**VIRGINIA ELECTRIC AND POWER COMPANY**  
**NORTH ANNA POWER STATION UNITS 1 AND 2**  
**PROPOSED TECHNICAL SPECIFICATION CHANGES**  
**REVISED CONTAINMENT ANALYSIS**

Attachment 1	Discussion of Changes
Attachment 2	Mark-up of Technical Specifications Changes
Attachment 3	Proposed Technical Specifications Changes
Attachment 4	Mark-up of ITS Changes
Attachment 5	Proposed ITS Changes
Attachment 6	Significant Hazards Consideration Determination

**Attachment 1**  
**Discussion of Changes**

**Figure 4.1**  
**Containment Air Partial Pressure versus Service Water Temperature**  
**(Revised Tech Spec Figure 3.6-1)**

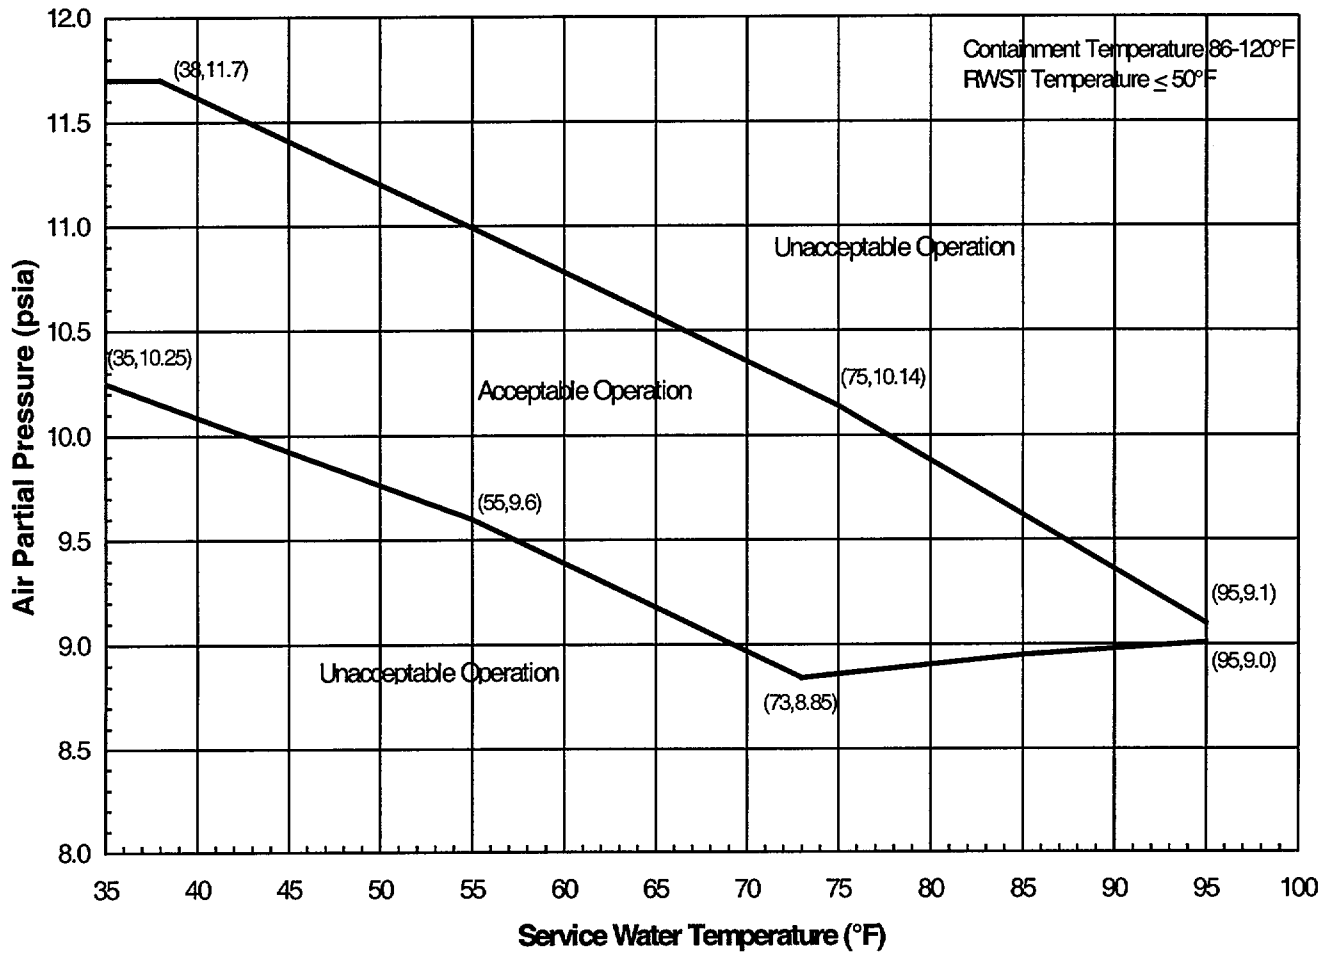
Technical Specifications Figure 3.6-1, "Containment Air Partial Pressure Versus Service Water Temperature" was revised as a result of the new containment analyses. The revised operating curve is provided as Figure 4.1. The peak pressure analysis sets the upper pressure limit below 38°F service water, the point where the peak pressure and depressurization analyses converge at 11.7 psia. The depressurization analyses create the upper pressure limit between 38°F and 95°F service water. The lower bound of the Technical Specifications containment air partial pressure operating curve is defined by the LHSI pump NPSH results for service water temperature greater than 73°F and by the RS pumps NPSH results for service water temperature less than 73°F. The containment air partial pressure is 8.85 psia for 73°F service water, where the curves intersect. This represents the minimum operating containment air partial pressure on Figure 4.1.

Figure 3.6-1 Containment Air Partial Pressure Versus Service Water Temperature

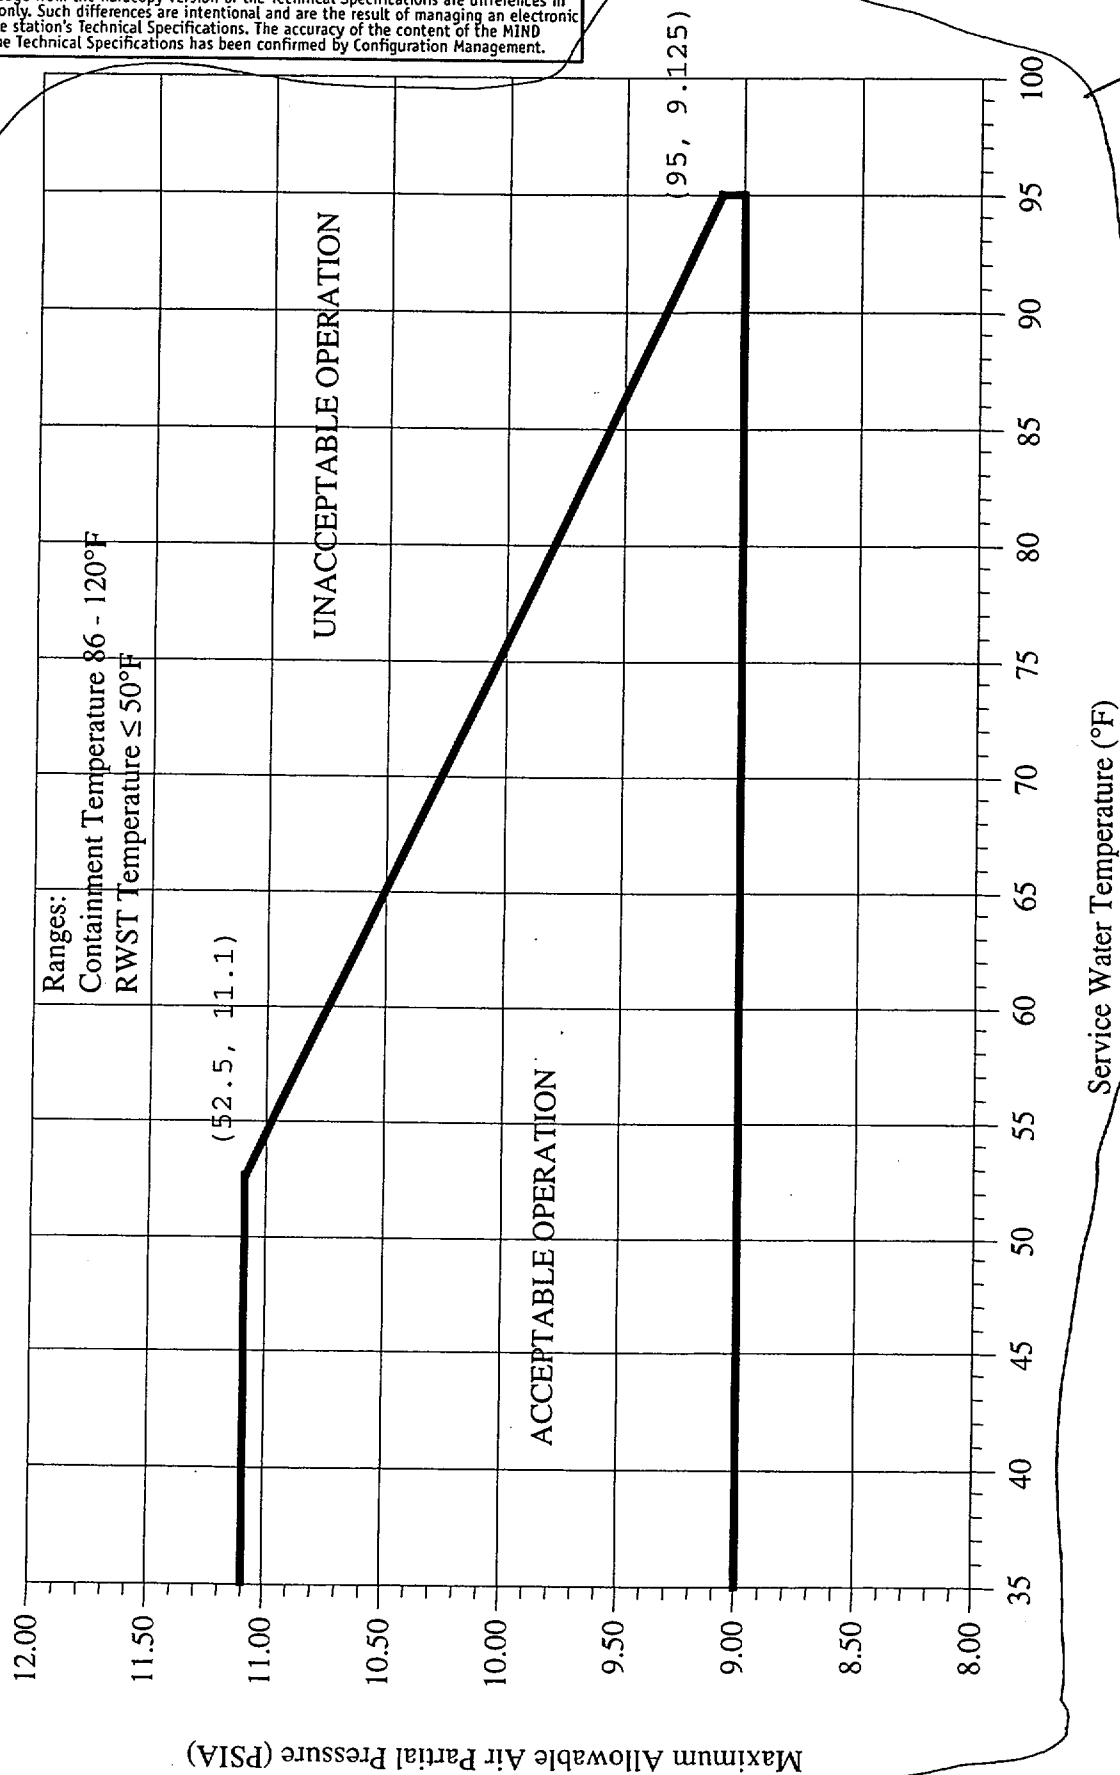
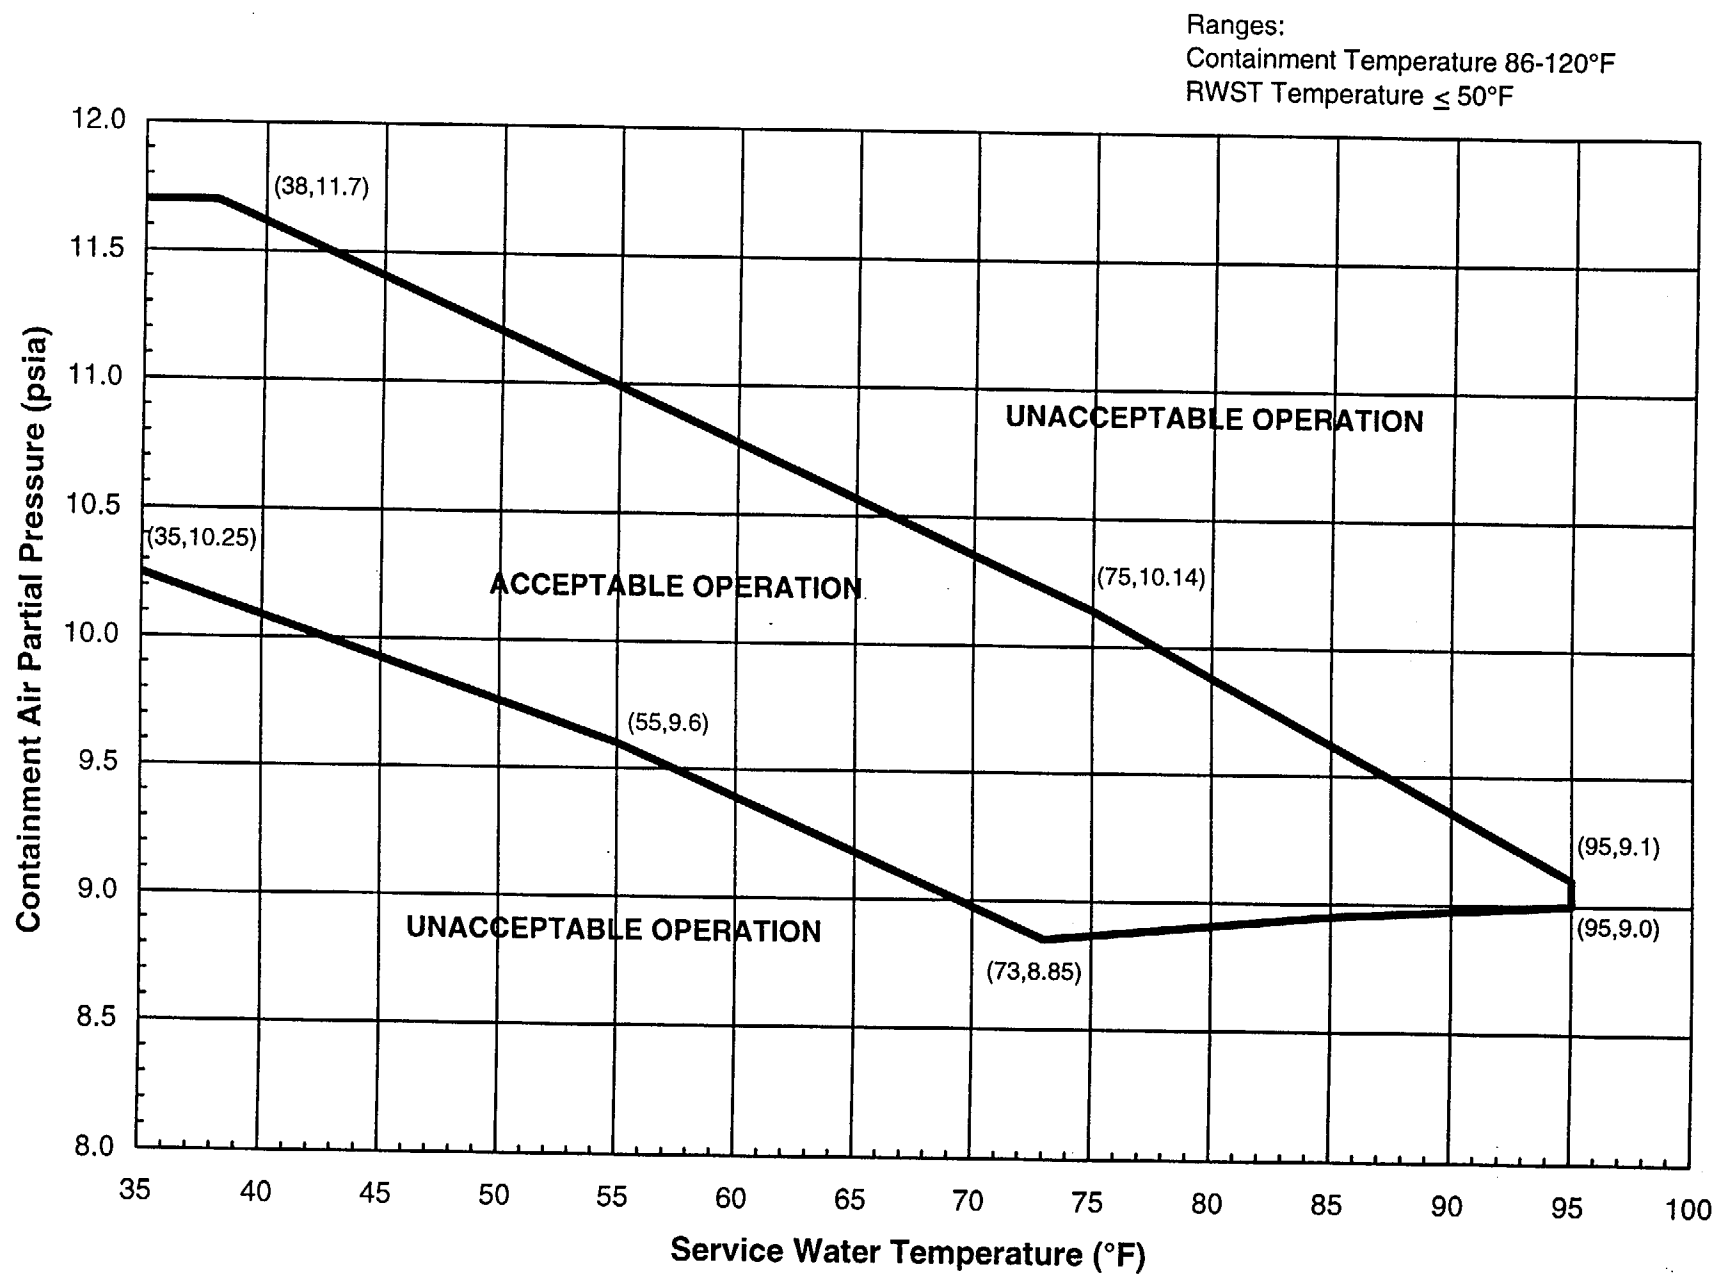
The specifications on the containment air partial pressure will be revised to the proposed operating curve in TS Figure 3.6-1, Containment Air Partial Pressure Versus Service Water Temperature. In addition, the text will be slightly modified to remove the reference to a constant air partial pressure lower limit of 9.0 psia, which is not a feature of the revised figure.

Replace with revise Figure 3.6-1

Figure 3.6-1 Containment Air Partial Pressure Versus Service Water Temperature

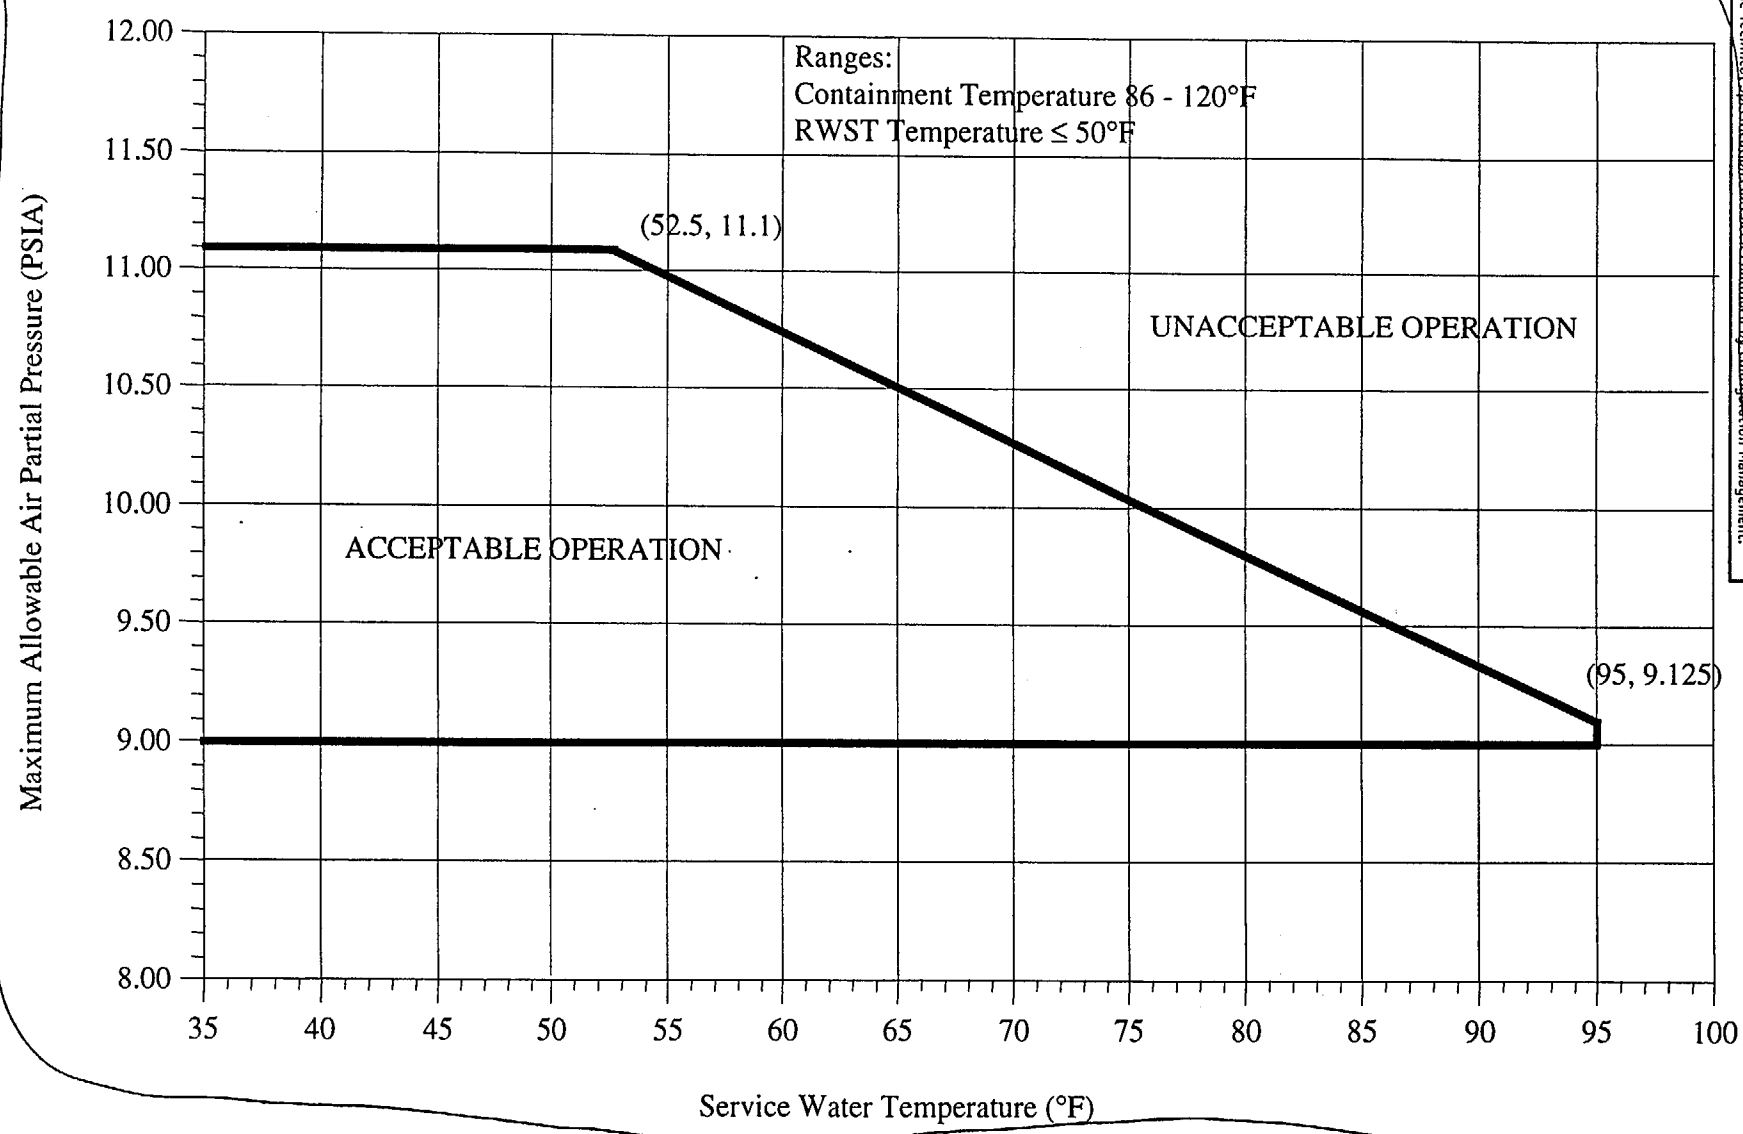
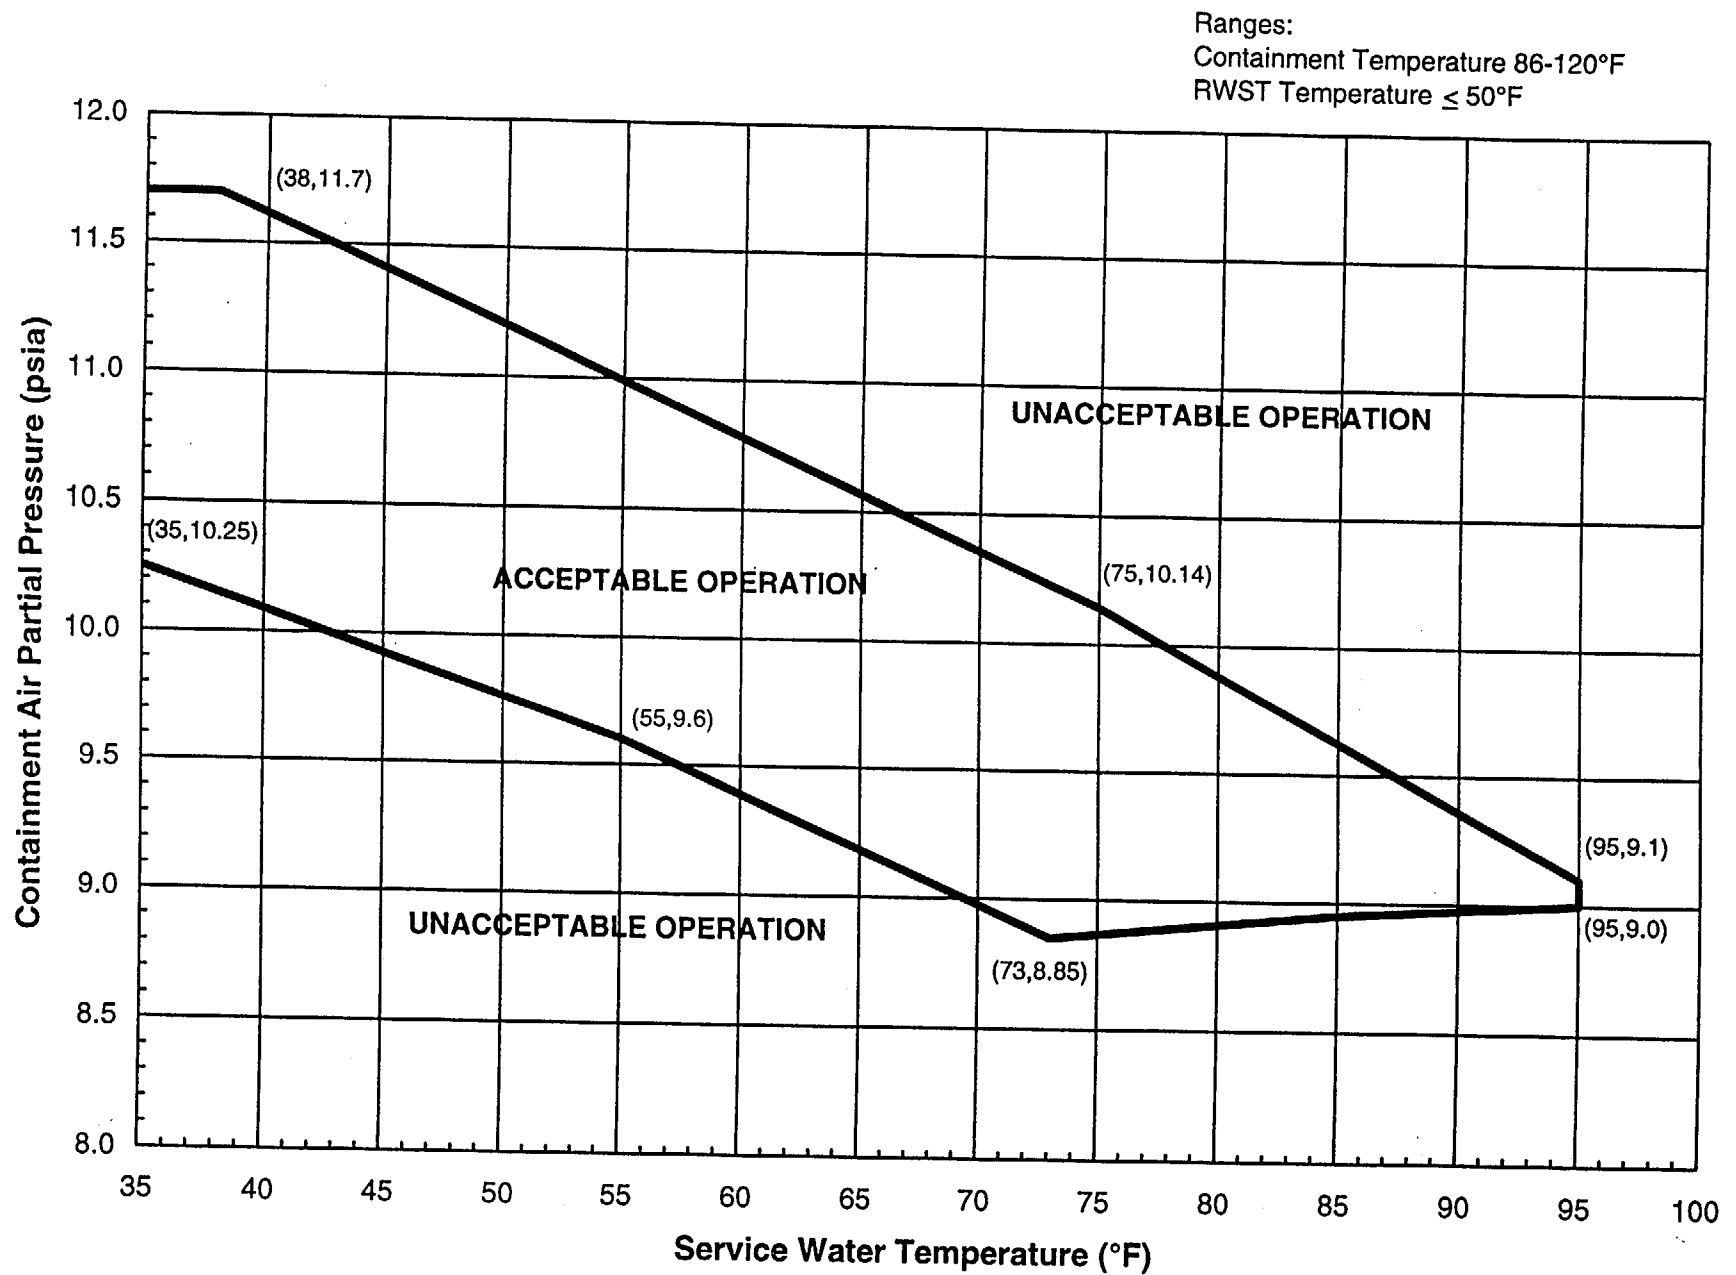
Replace w  
new figure  
3.6-1
